8 PHILLIP STREET
PARRAMATTA

DA 8 PHILLIP STREET DRAWING LIST

Status
DEVELOPMENT APPLICATION

Sheet title
GROUND GA

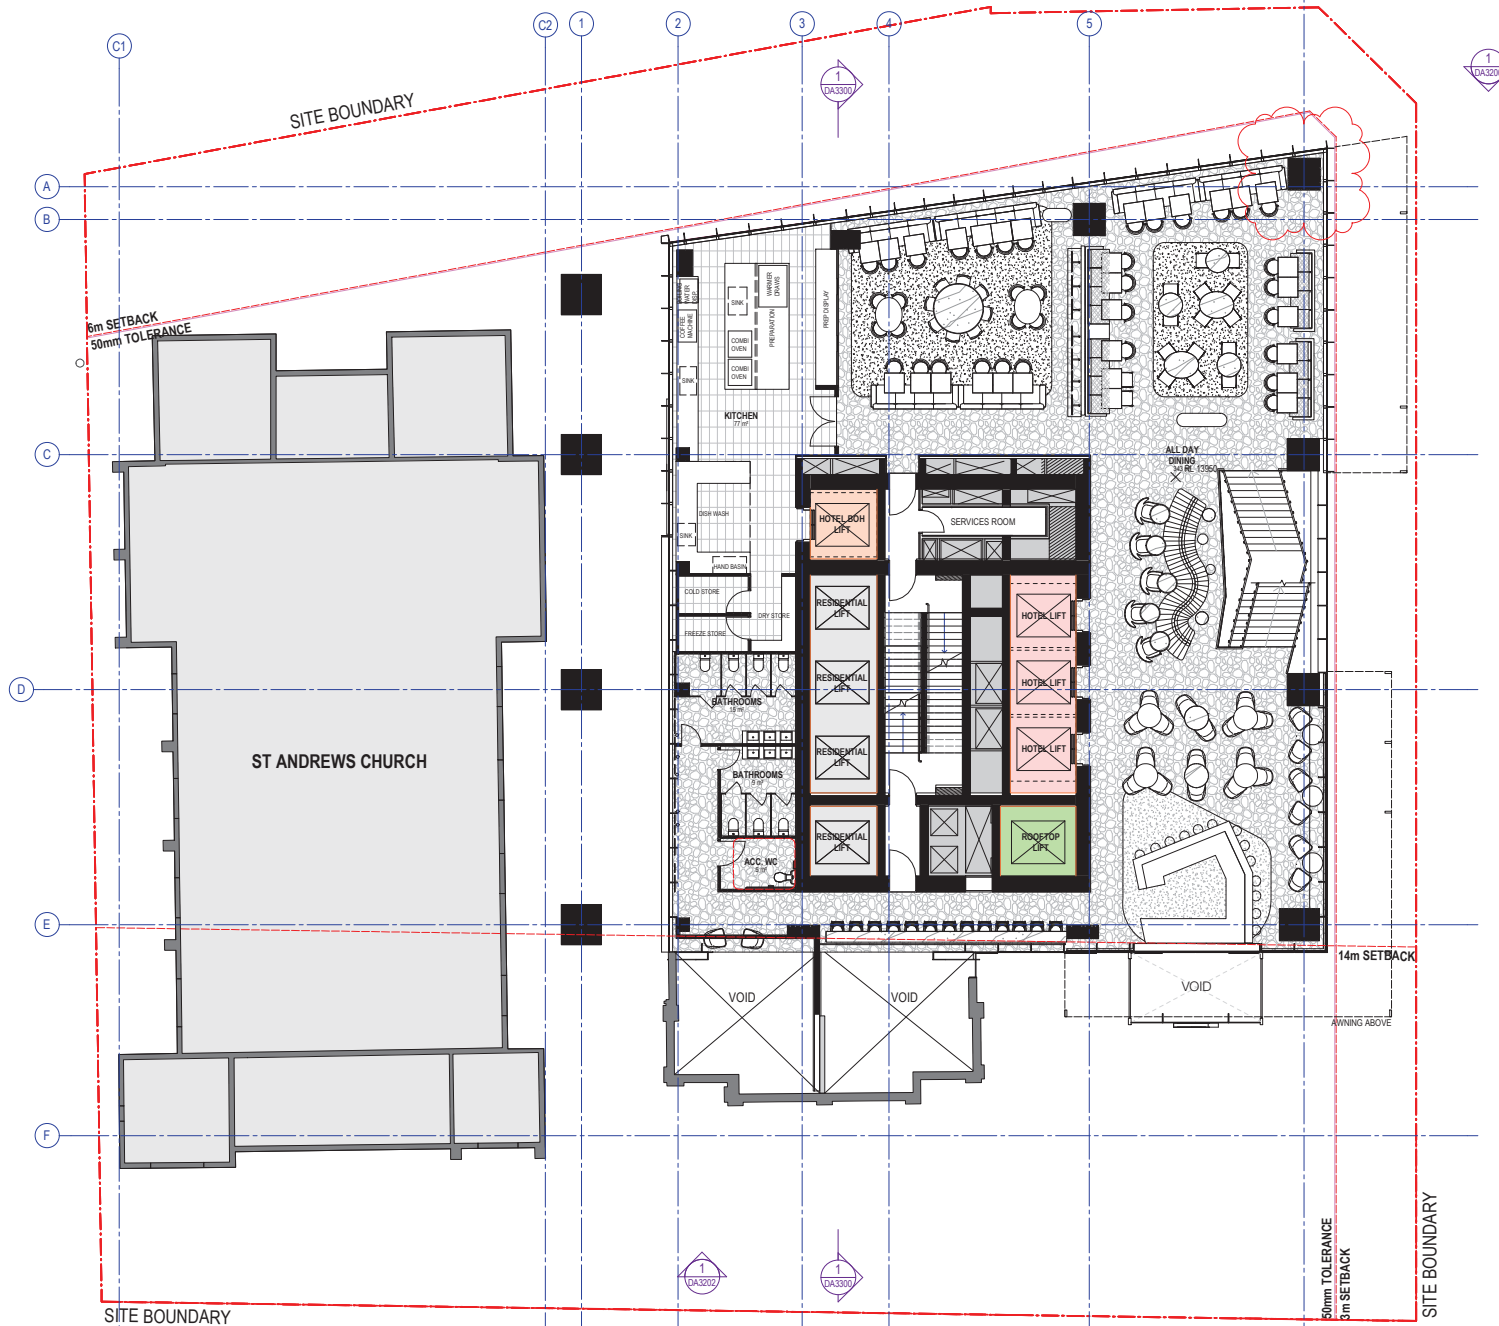
1. LEVELS AMENDED / ADDED.
2. KERB FORM AMENDED.
3. EXTENT OF EXTERNAL PAVERS AMENDED.
4. FRONT OF SUBSTATION FLOOR FINISH AMENDED.
5. HERITAGE DOORS REINSTATED.

Sheet title
LEVEL 2 GA MEETING/ PRIVATE DINING ROOMS

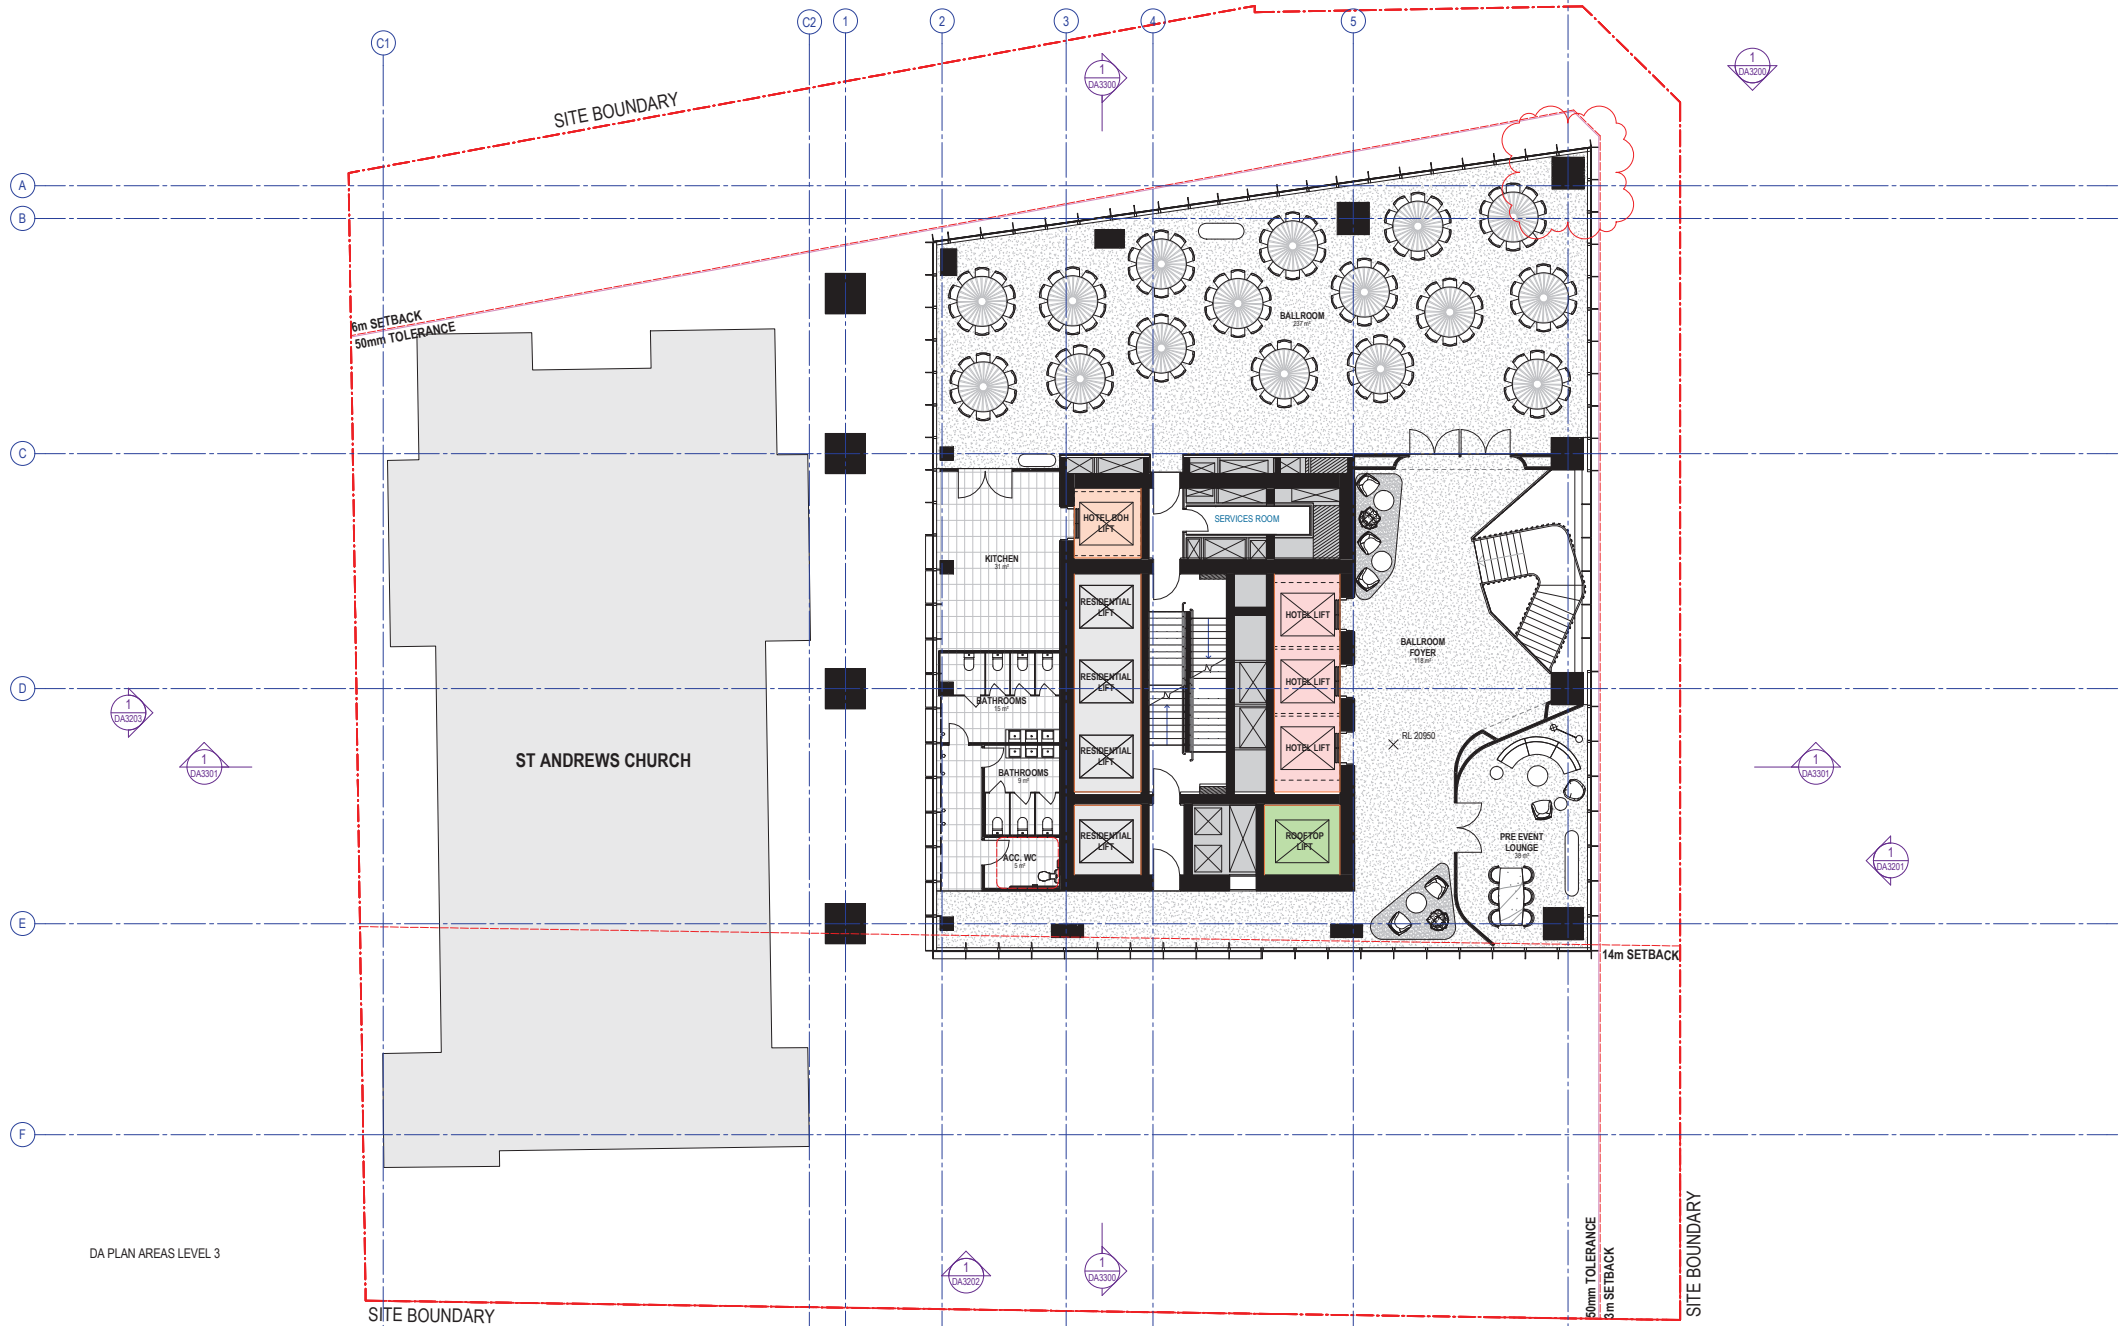
1. WIND BREAK AWNING ADDED.

Sheet title
LEVELS 8-16 GA HOTEL

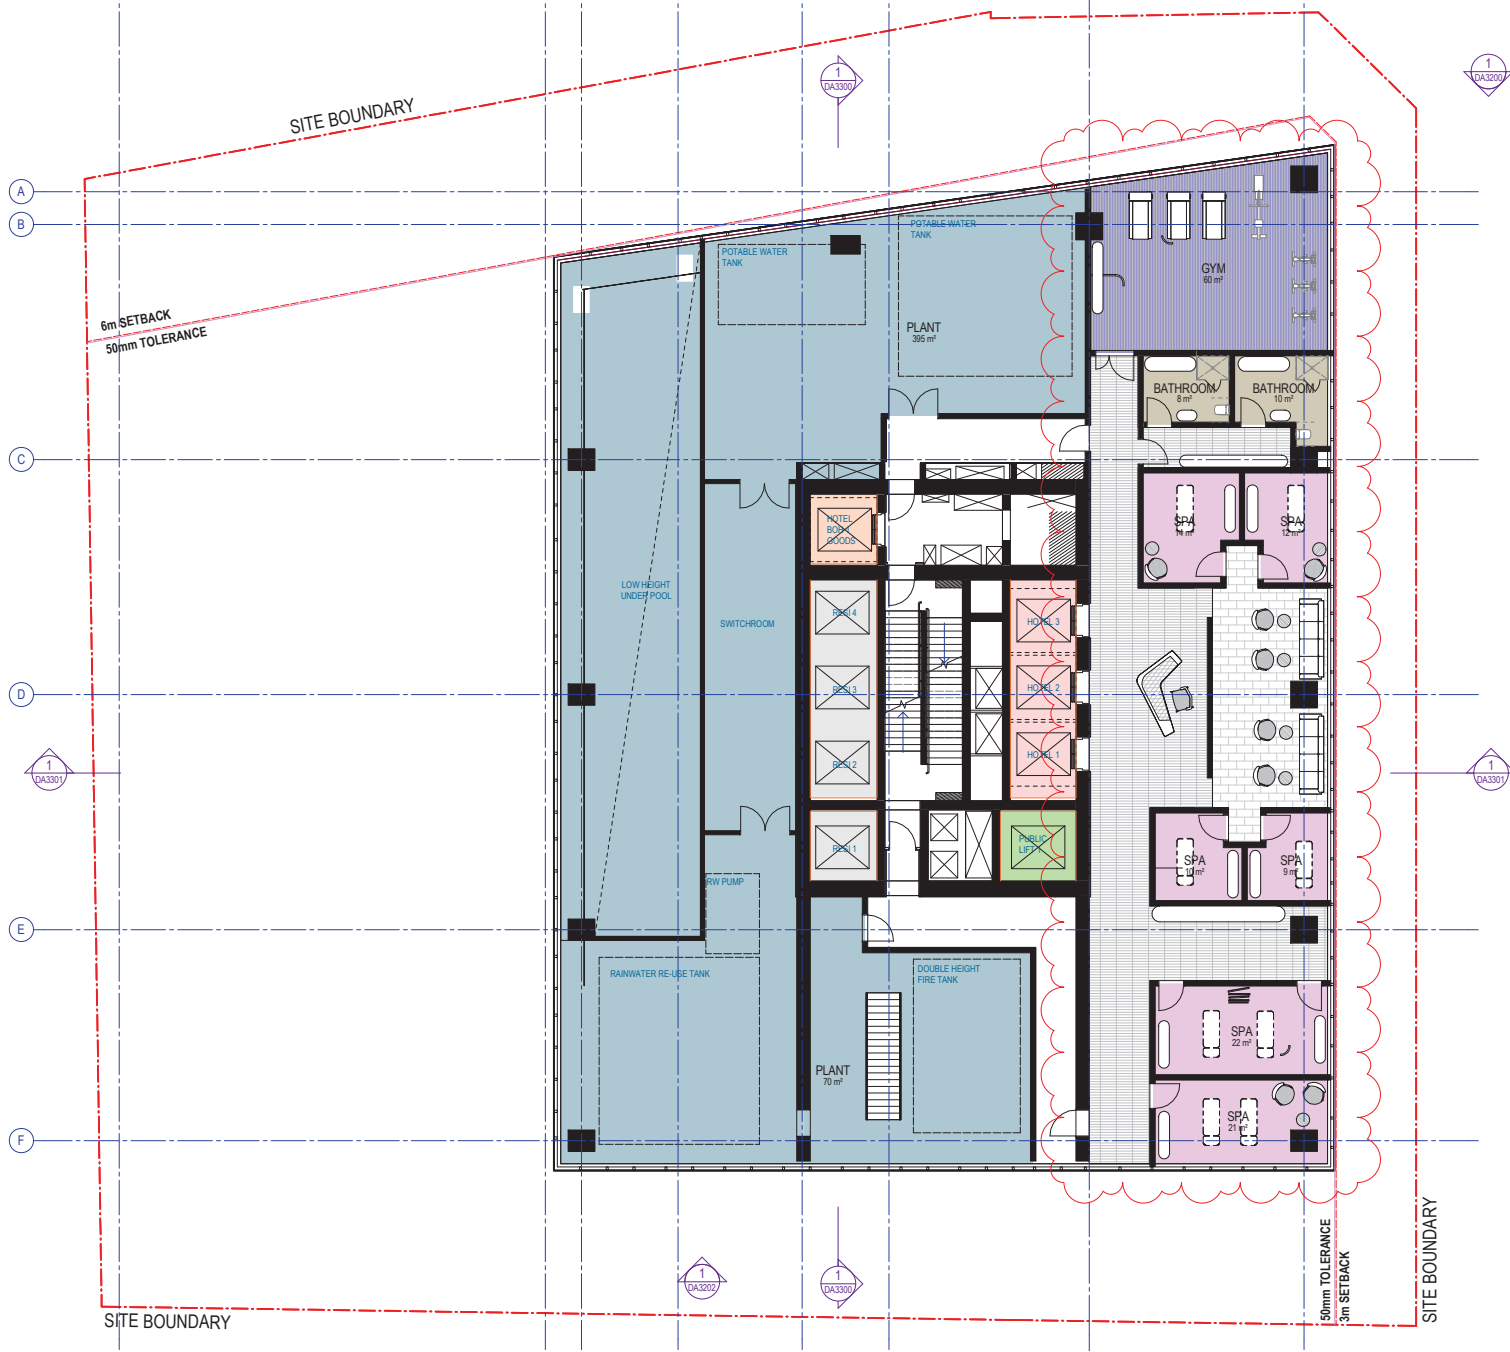
1. COLUMN LOCATION AMENDED.

Sheet title
LEVELS 24-33, 35, 39-40, 42, 46, 48 GA

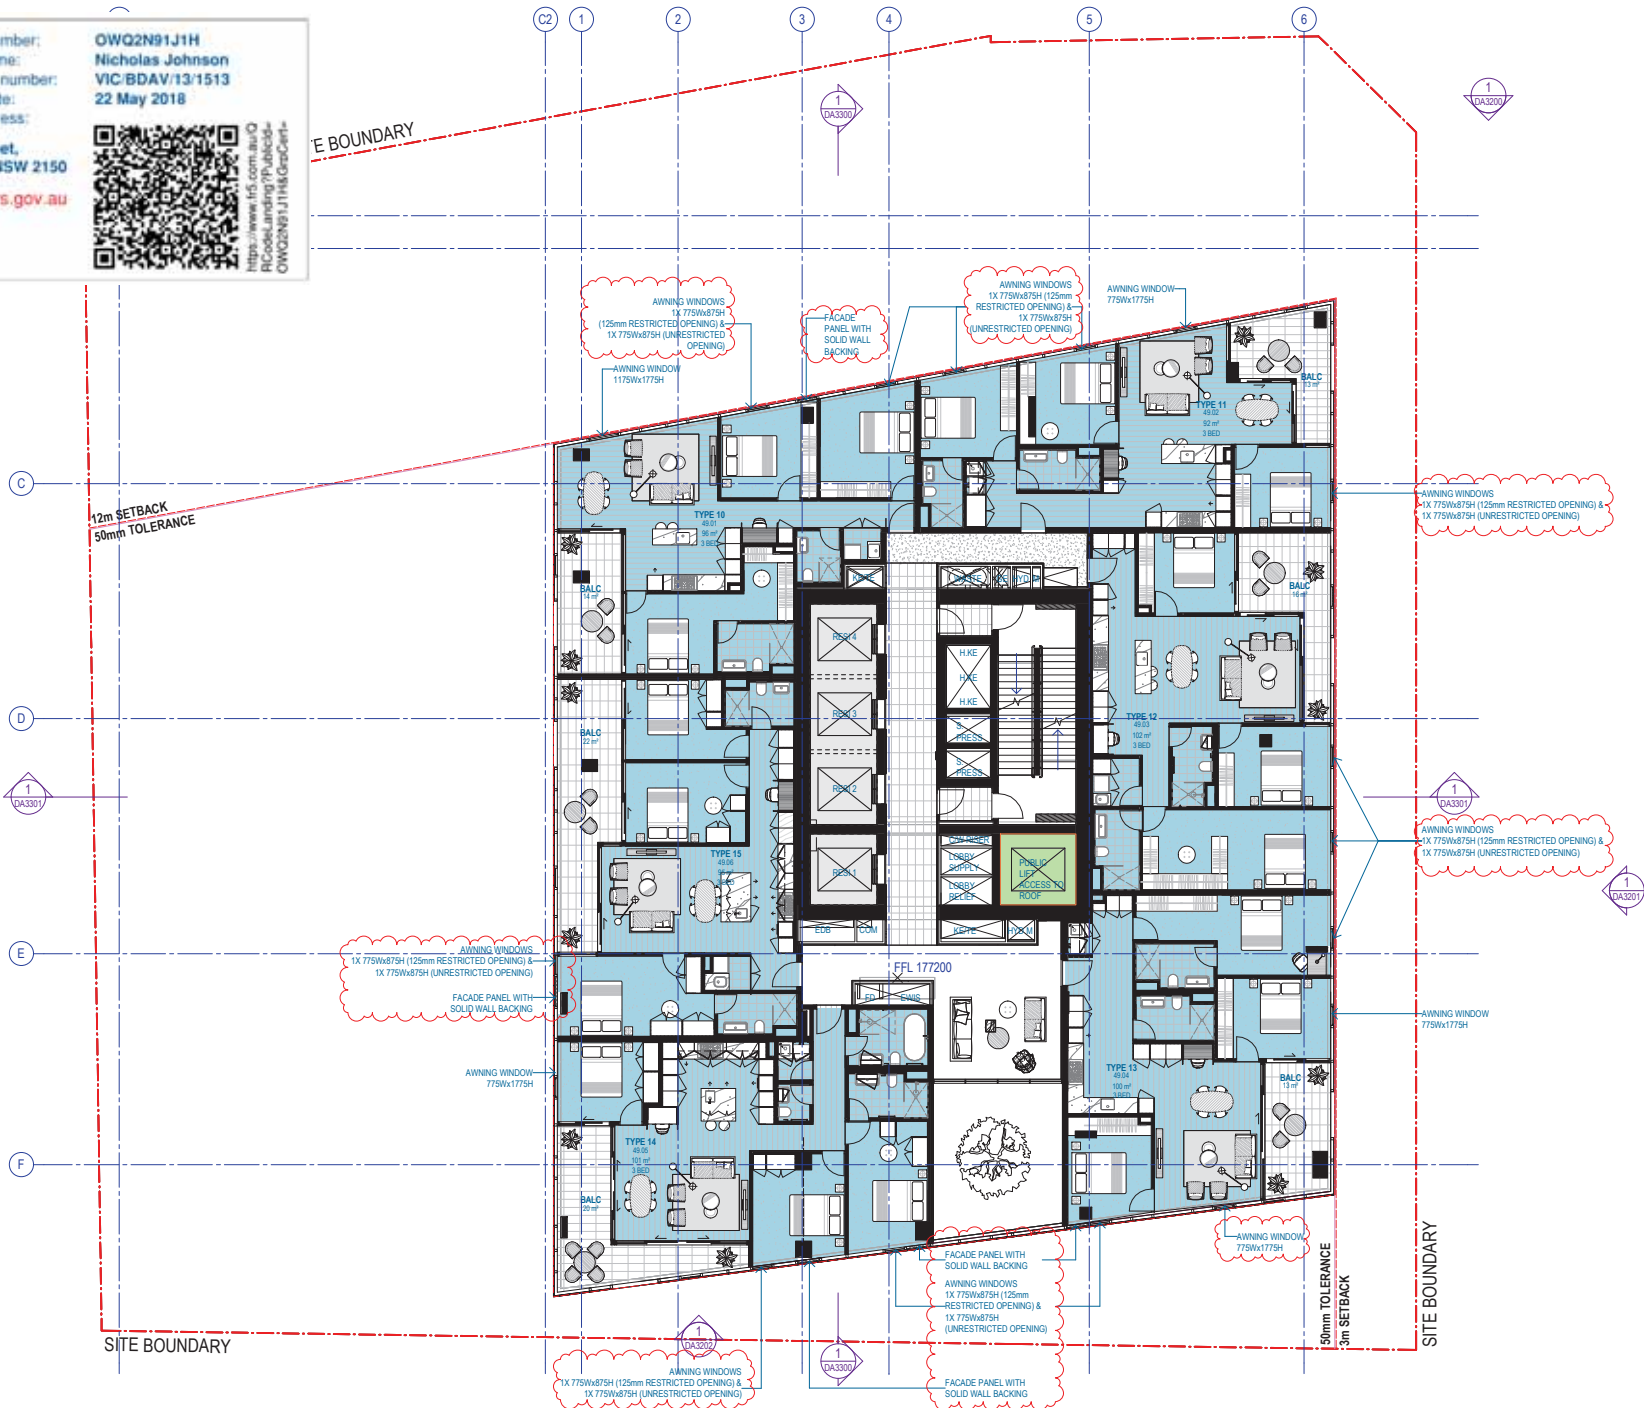
1. AWNING WINDOWS ADDED.
2. INTERNAL BLINDS PROVIDED AS STANDARD IN ALL RESIDENTIAL UNITS.

Sheet title
LEVELS 49-51 GA

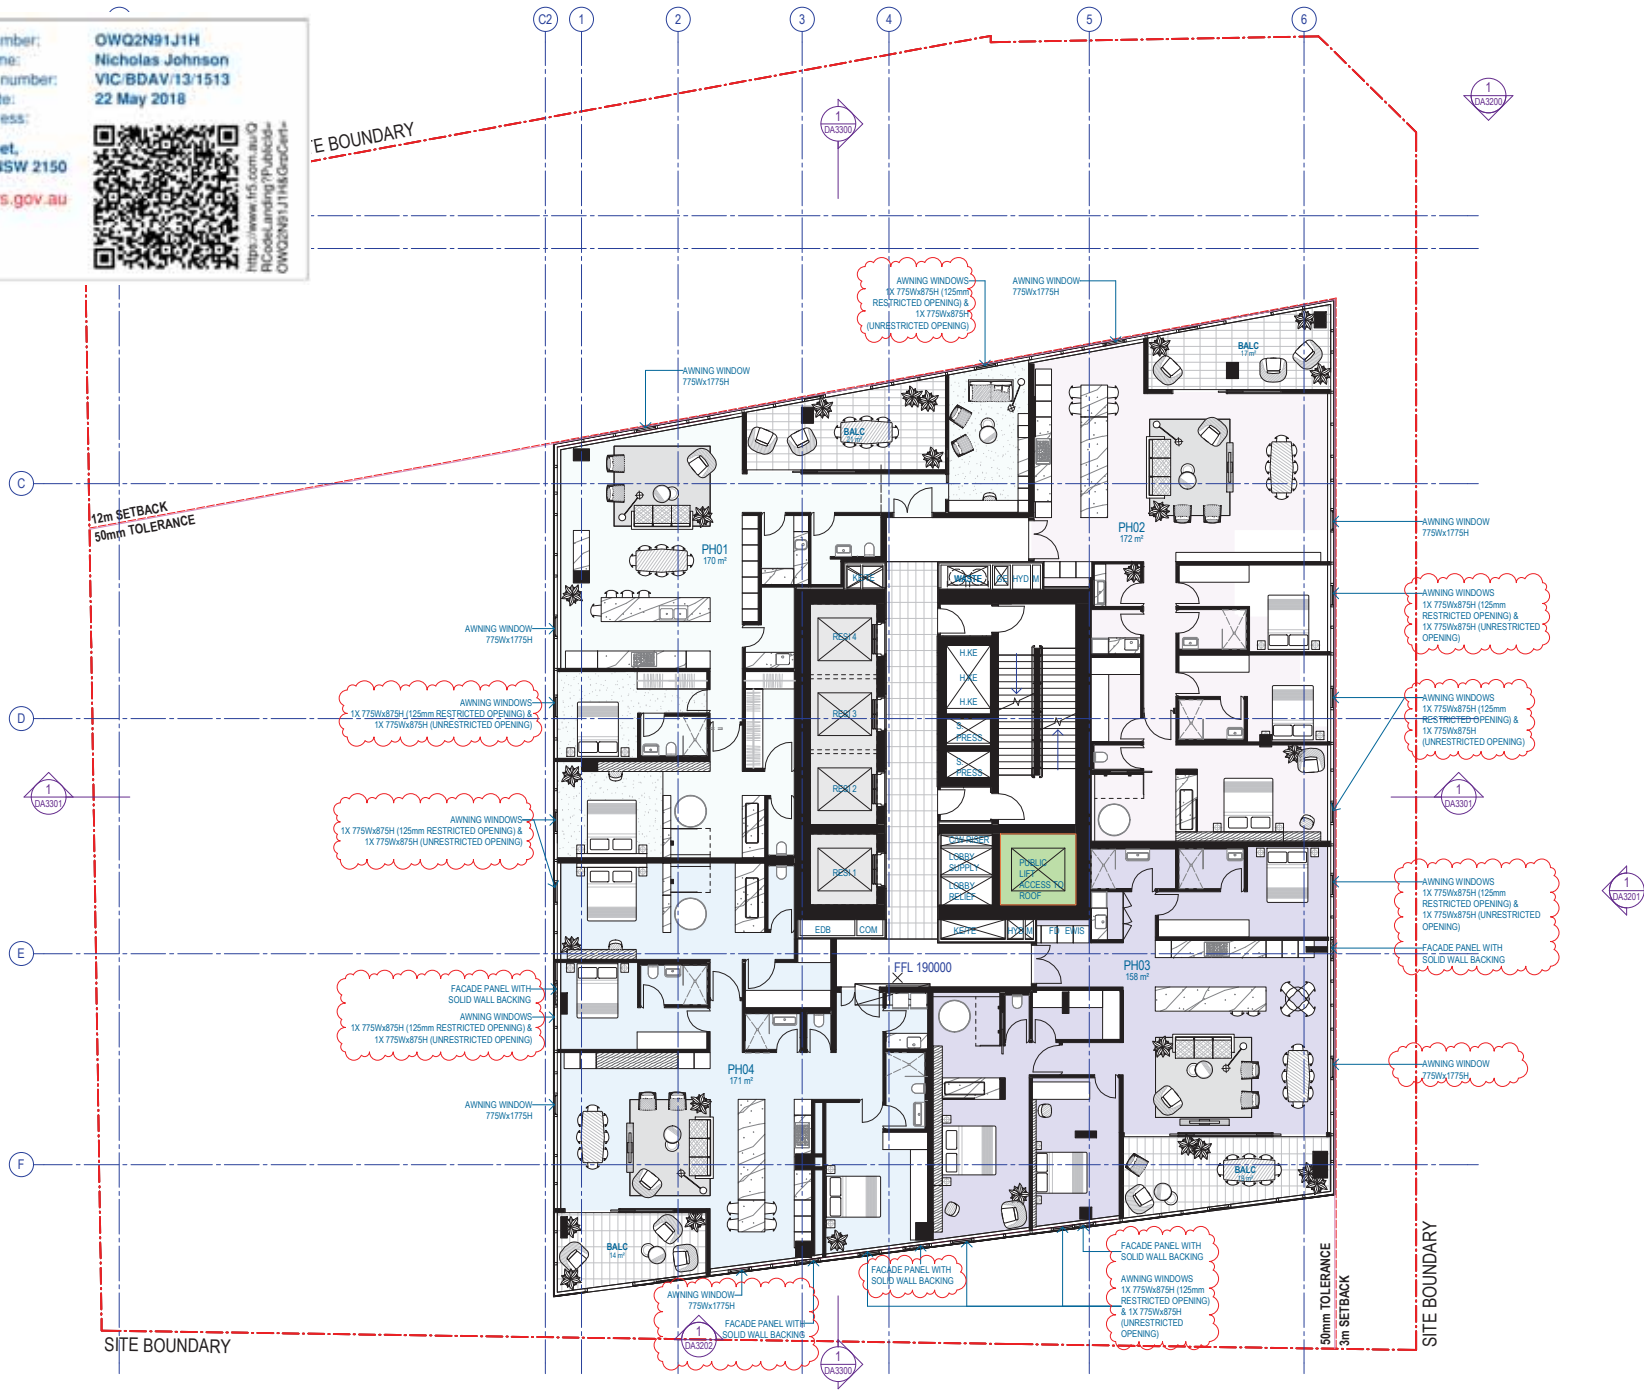
1. AWNING WINDOWS ADDED.
2. INTERNAL BLINDS PROVIDED AS STANDARD IN ALL RESIDENTIAL UNITS.
